CITY OF BOULDER
PLANNING BOARD MEETING AGENDA
DATE: August 21, 2014
TIME: 6 p.m.
PLACE: Council Chambers, 1777 Broadway

AGENDA TITLE: Public hearing to consider **Concept Plan**, LUR2014-00045, for the phased redevelopment of the 8.45-acre Armory site located at the southeast corner of Broadway and Lee Hill Dr. with a mixed-use project including the Phase 1 development of the western half of the site with 127 residential units, a 10,700 s.f. arts market/ studio space, 10,900 s.f. of retail/ flex space and up to 13,100 s.f. of restaurant space including a new 9,500 s.f. brew pub to be located in the existing “mess hall” building; and the Phase 2 development of the eastern half of the site with 65 mixed density residential units.

DATE OF COMMENTS: **July 7, 2014**
 CASE MANAGER: **Chandler Van Schaack**
 PROJECT NAME: **The Armory**
 LOCATION: **4750 BROADWAY**
 COORDINATES: **N09W06**
 REVIEW TYPE: **Concept Plan Review & Comment**
 REVIEW NUMBER: **LUR2014-00045**
 APPLICANT: **LIZ PETERSEN**

Figure 3: Land Use Map

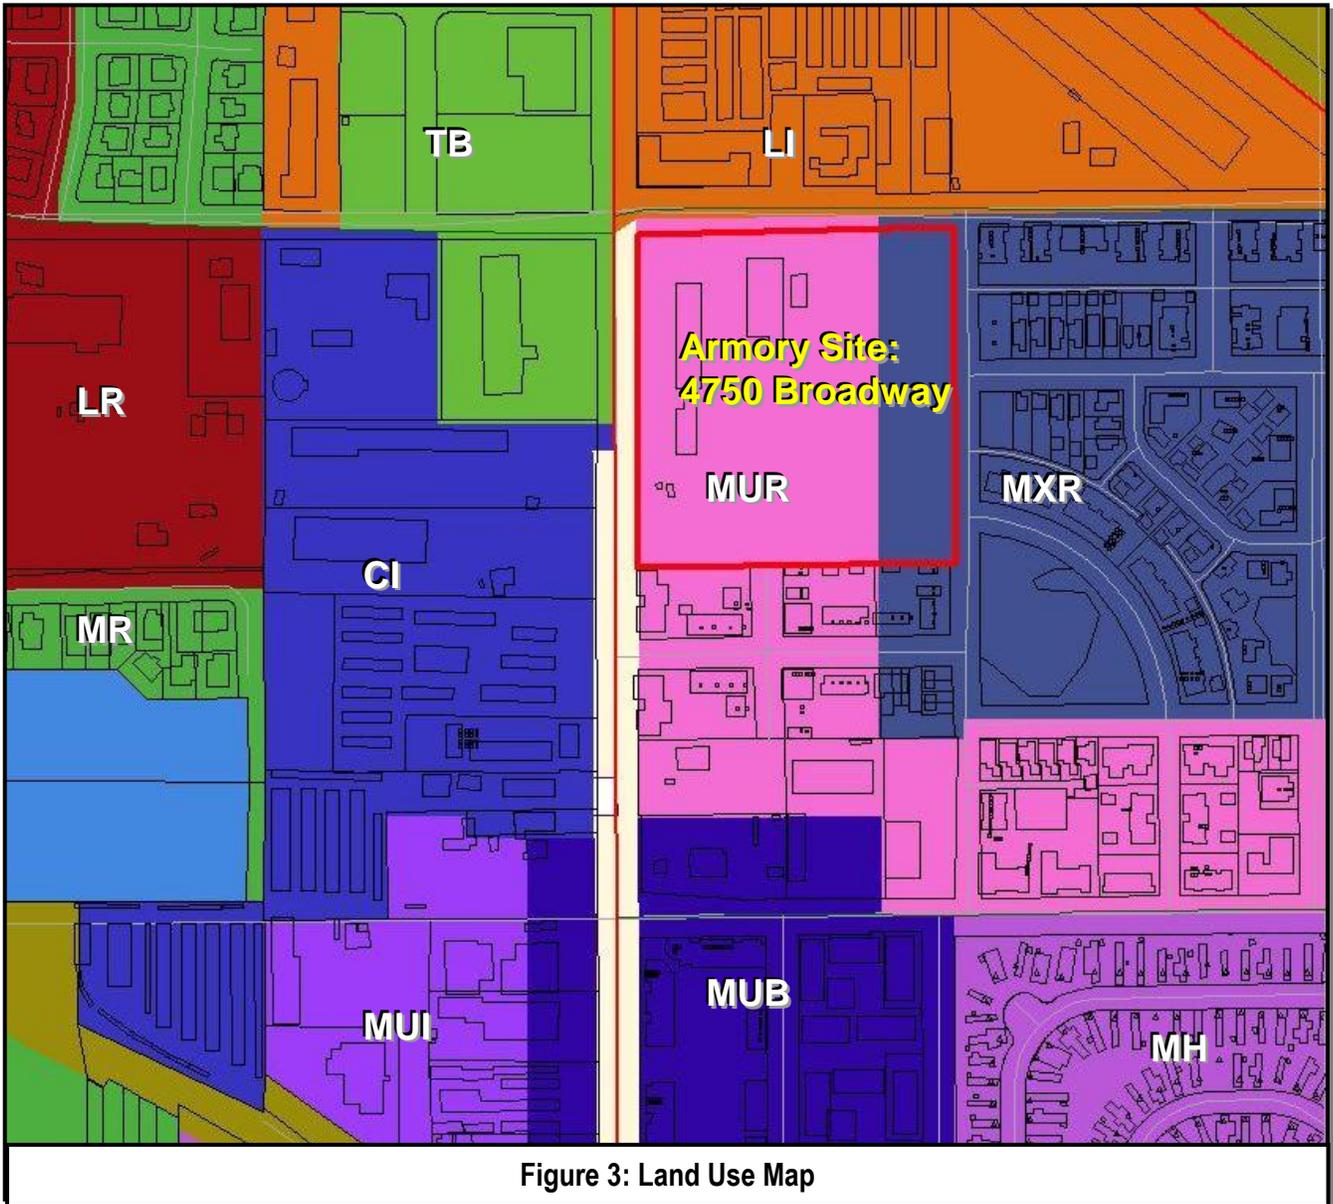
Overall, staff finds the proposed mixed use development to be largely consistent with the BVCP Land Use Designations for the site, as well as with many of the broader policy goals contained in the BVCP. Some BVCP policies with which the current Concept Plan proposal is consistent include:

Figure 4: Zoning Map

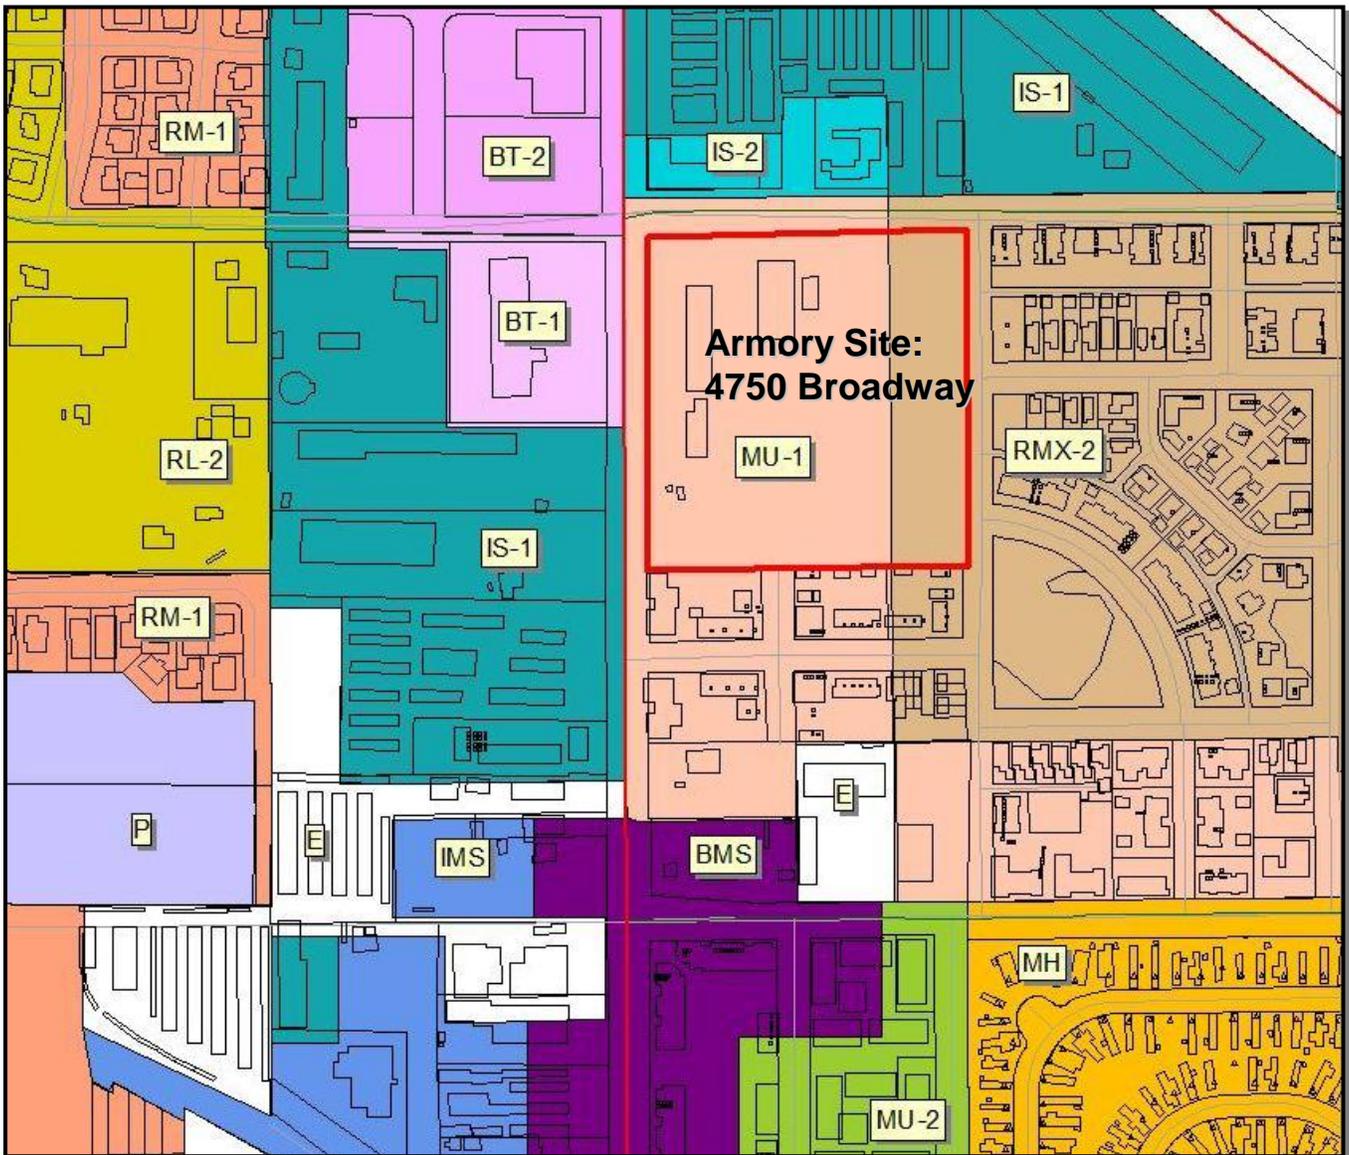
Zoning: The site is split zoned, with the western 75% of the site (approx. 282,504 sq. ft.) zoned MU-1 (Mixed Use – 1) and the eastern 25% of the site (approx. 90,292 sq. ft.) zoned RMX-2 (Residential- Mixed 2). Please see **Figure 4** below for a Zoning Map. Pursuant to section 9-5-2, B.R.C. 1981, these zoning districts are defined as follows:

Addendum: Preliminary Street Sections

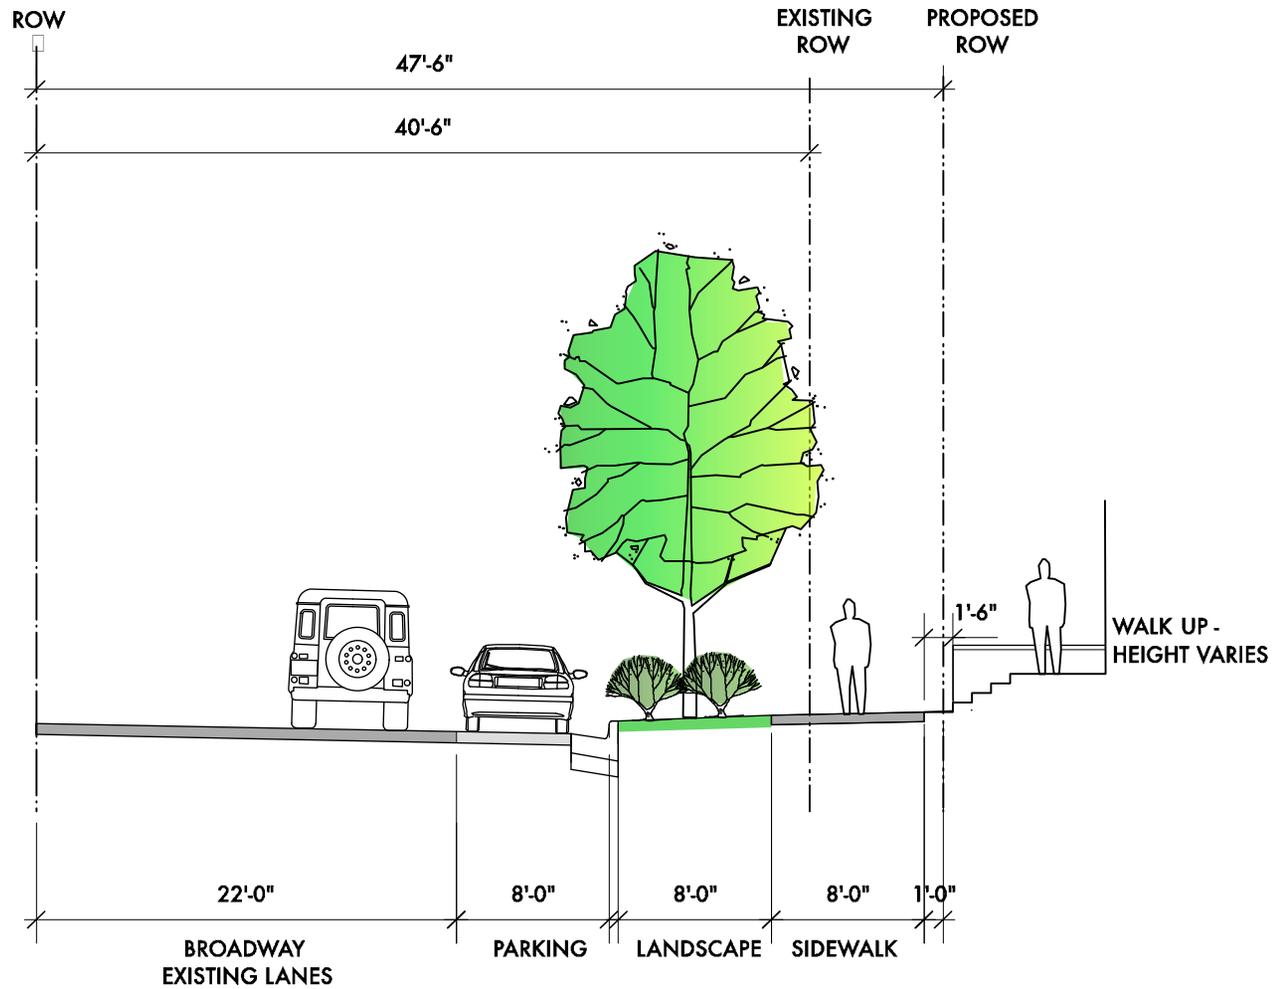
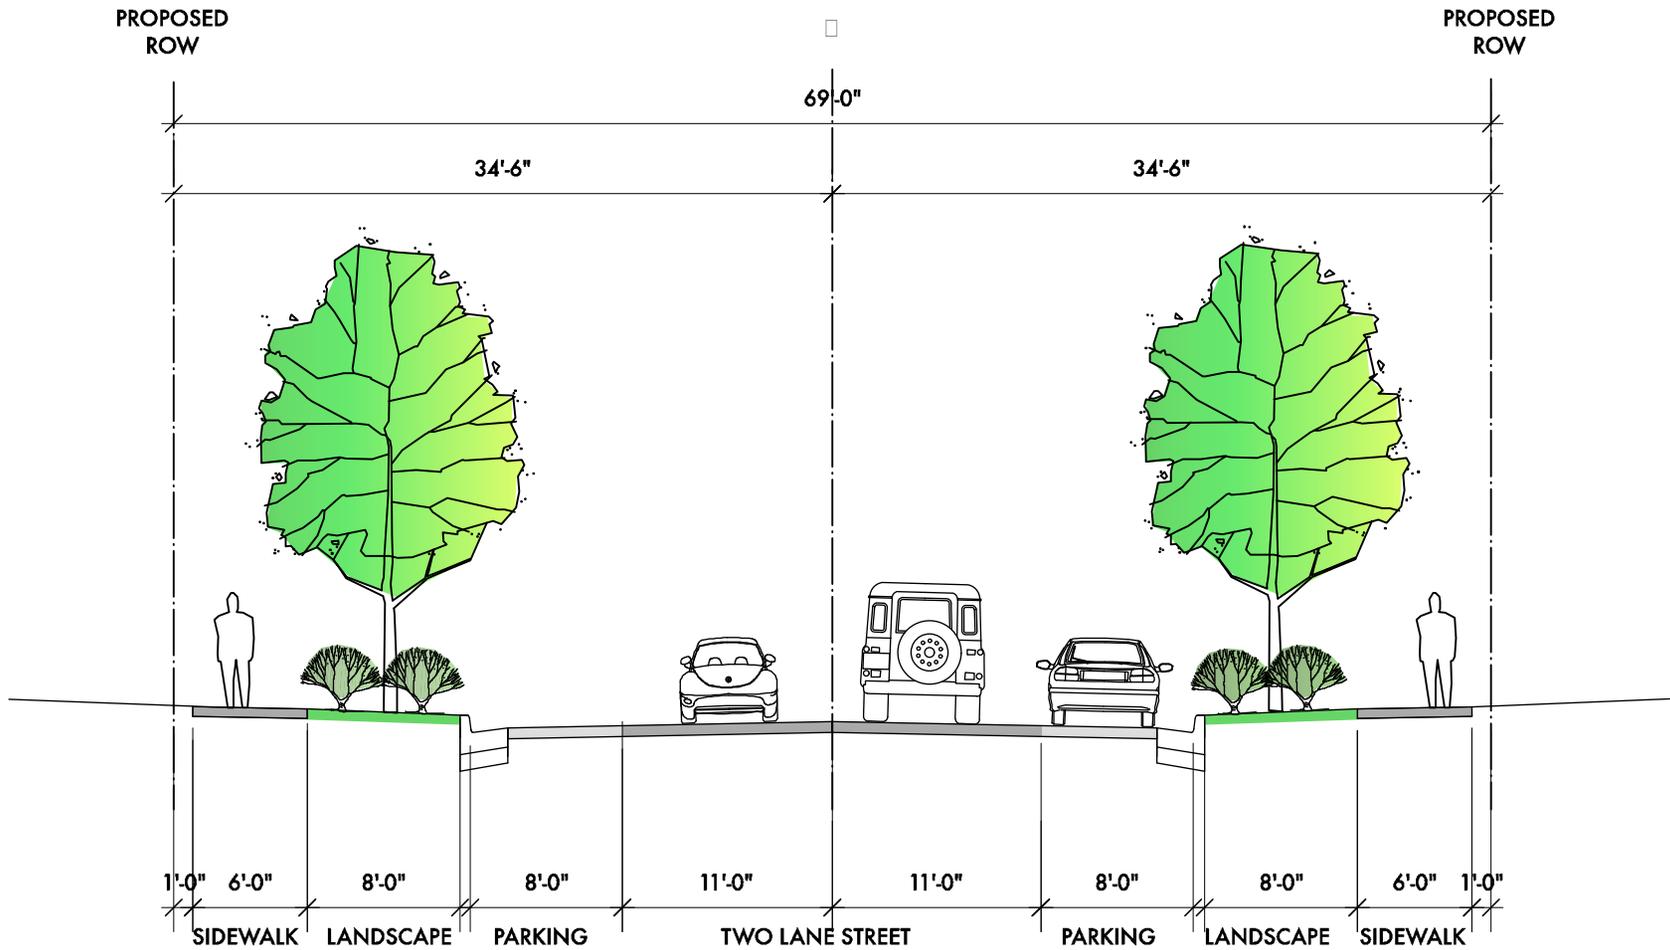
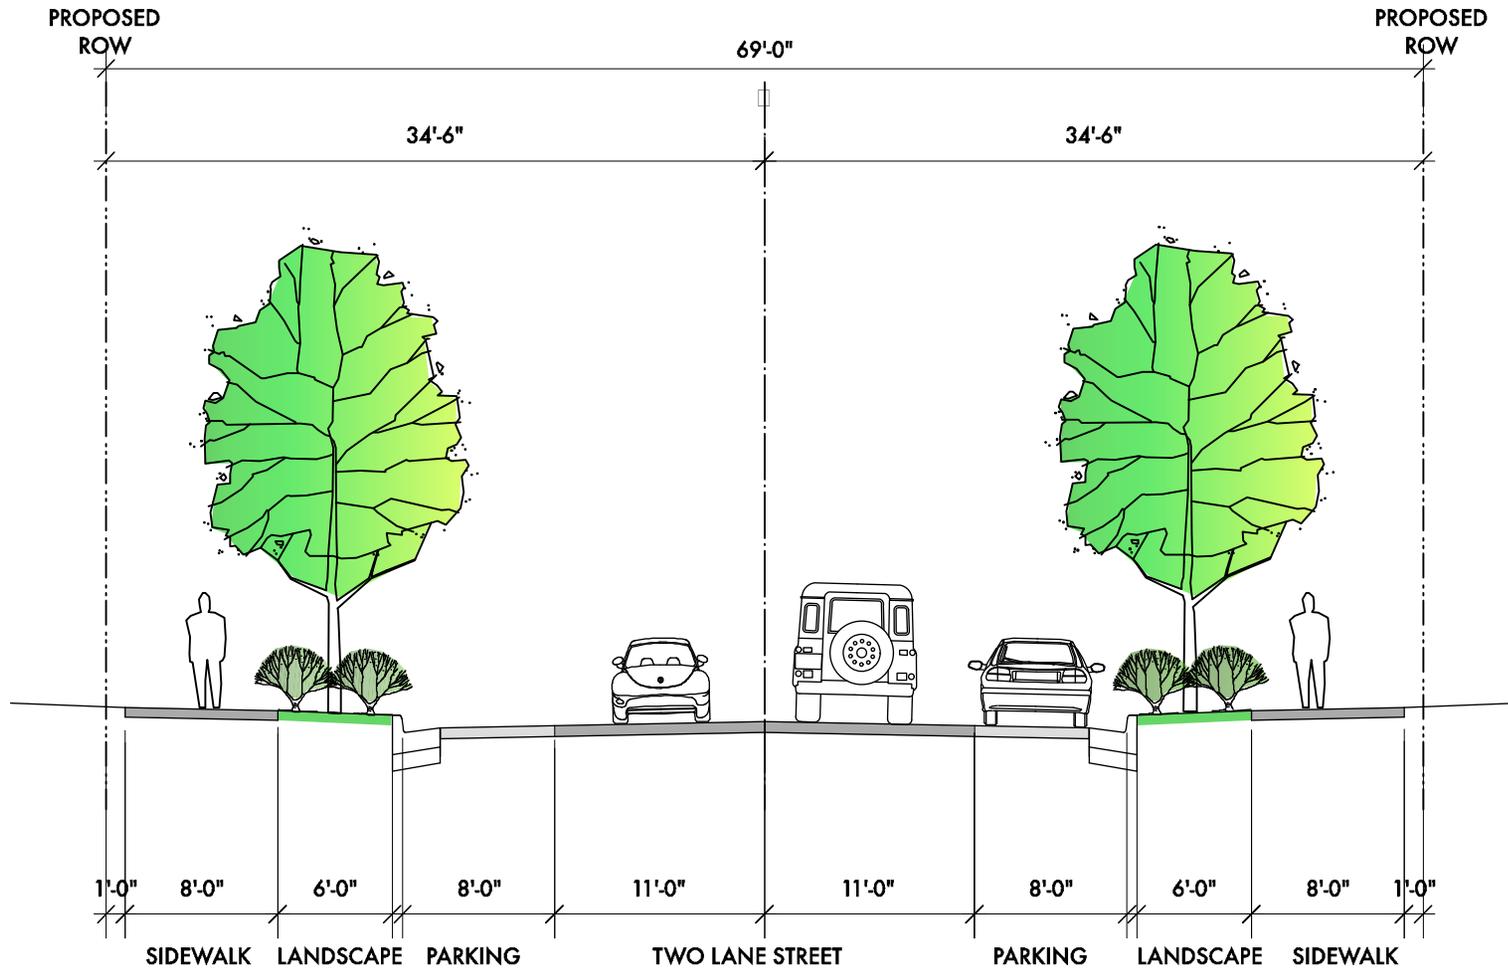
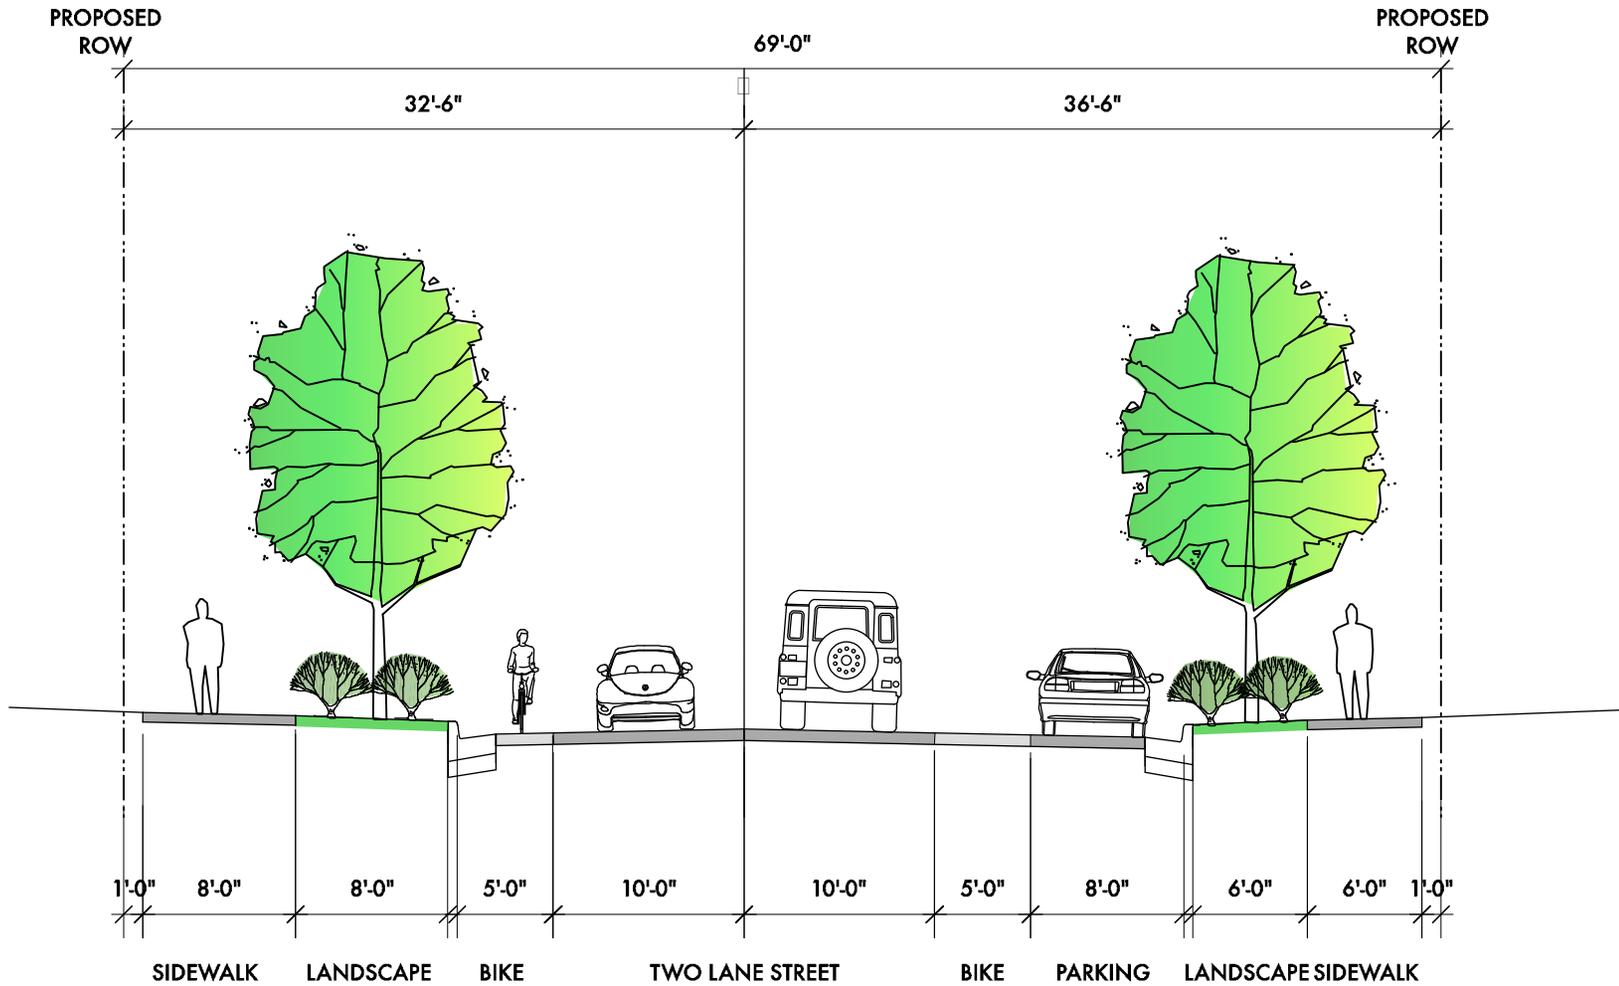
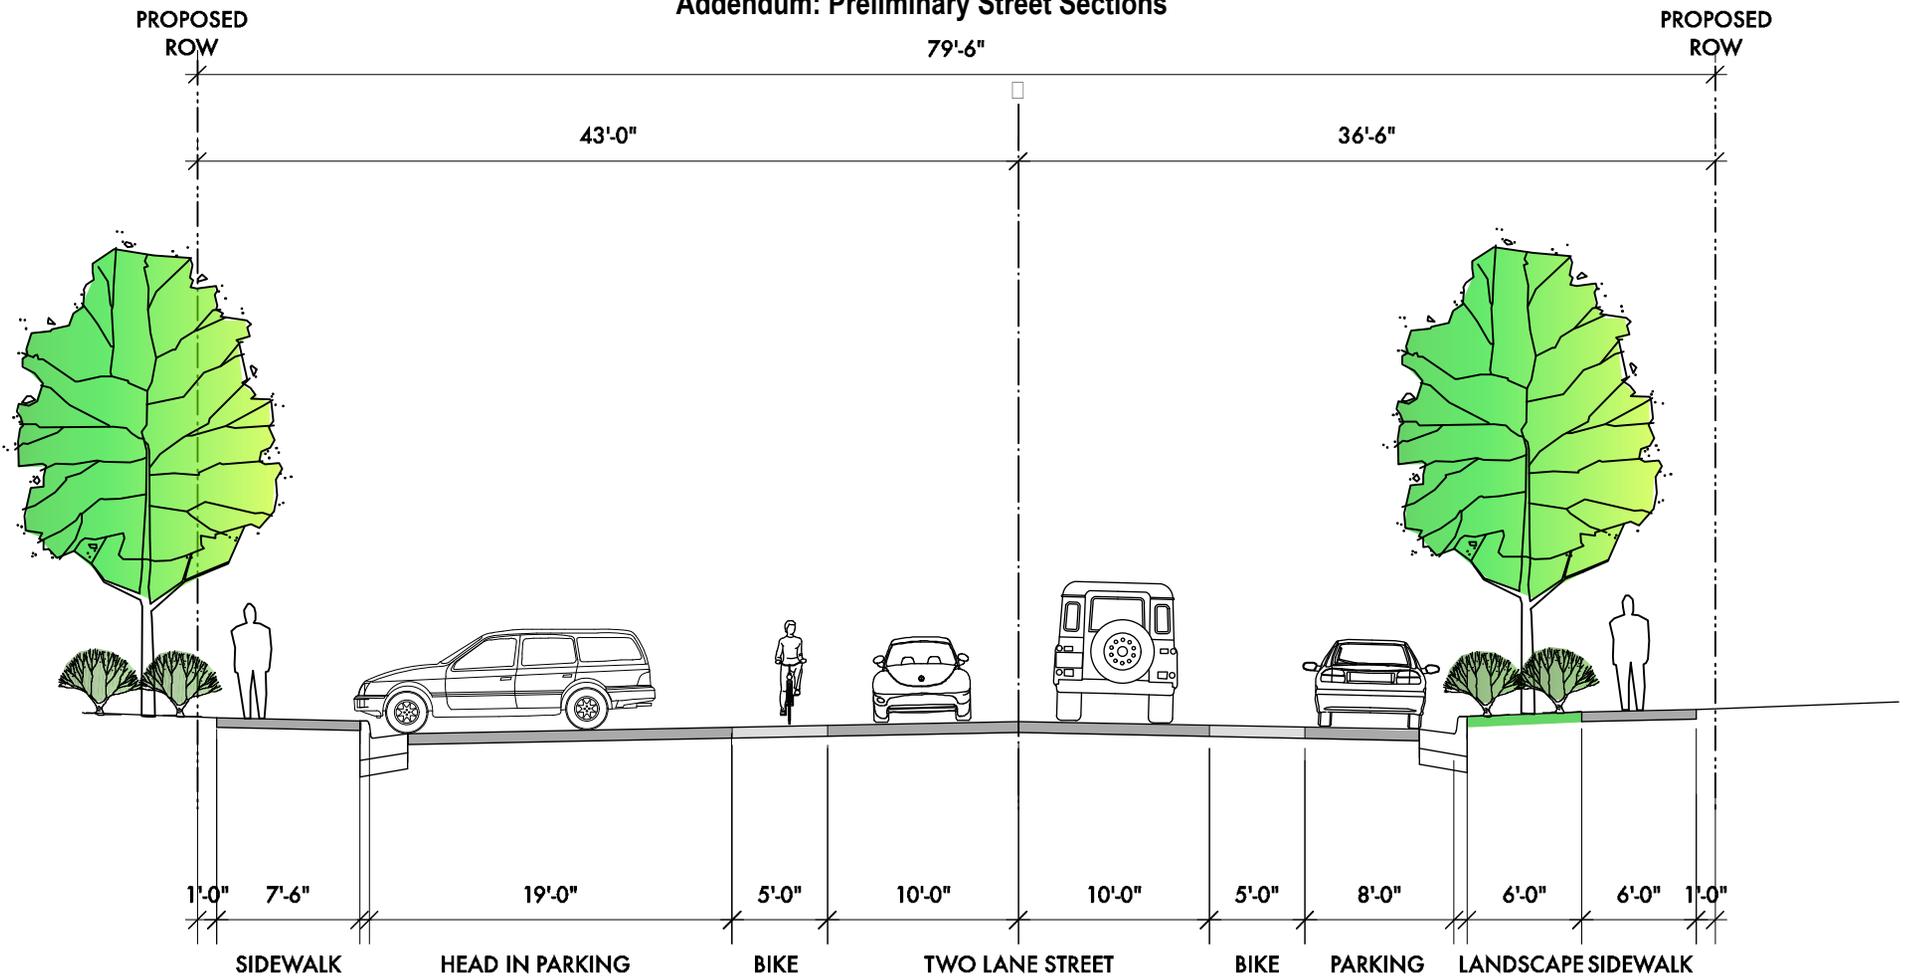
Overall, the proposed streets through the site are consistent with the NoBo Plan and will serve to enhance connectivity in the area and potentially reduce traffic on Broadway. The proposed street sections appear to be consistent with previous discussions with the applicant. Staff has some concerns regarding the alignment of the access points on Broadway and Lee Hill, which are outlined in further detail below.
